Starter Clutch and Flywheel Replacement

Models: Model Year 2016-2017 XDiavel (all model and country versions)

Recall Bulletin SRV-TSB-18-001

Flywheel and
starter clutch kit
part no. 69928312A

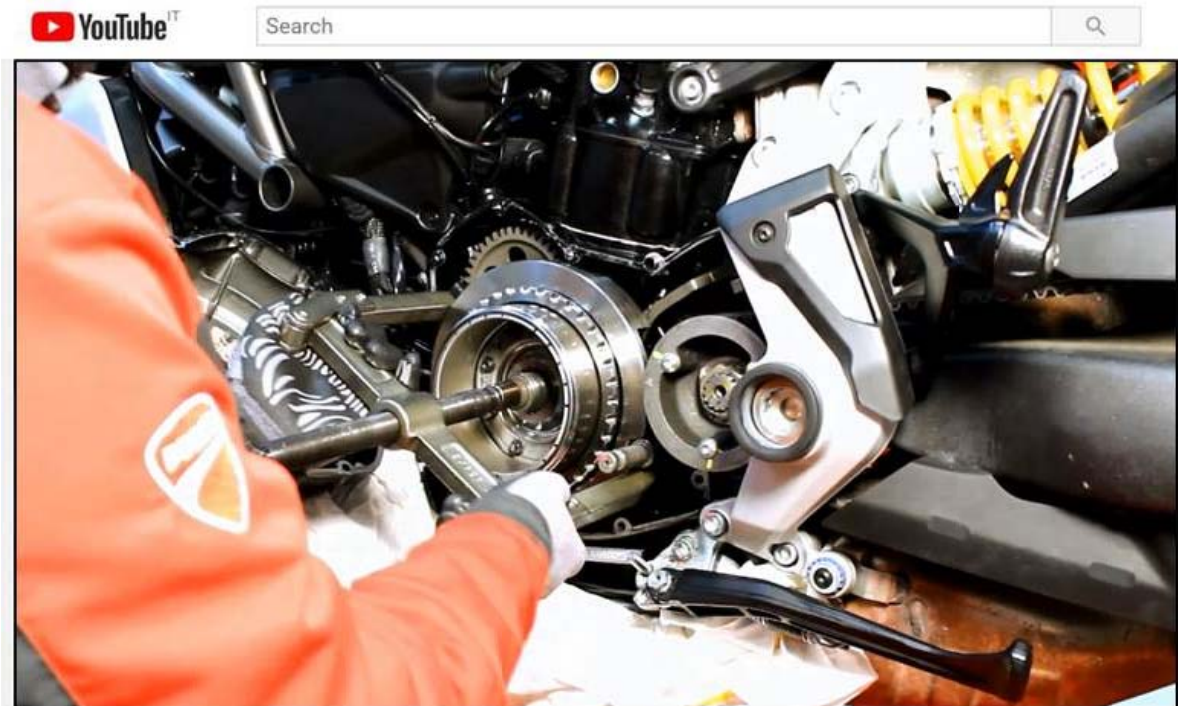
On the above-mentioned model Ducati received several reports of the starter motor cranking at idle without driving the engine, resulting in an engine no-start condition. The analysis of network dealer reports, and of the returned components, revealed that the cause of the phenomenon described above is starter clutch assembly breakage. Therefore, the starter clutch ignition assembly has been redesigned to make it more robust and prevent its possible breakage by introducing a reinforced new starter clutch and flywheel.

This technical solution has been introduced in the production line; we have decided to preventively replace all the starter clutch ignition assemblies mounted on the bikes produced before the modification with a dedicated kit that includes all the updated components.

The part no. of the dedicated kit for XDiavel model is part no. 69928312A.

The flywheel and starter clutch assembly is pre-assembled with a service screw which must be removed; the kit also includes 8 M6x25 screws for the final assembly.
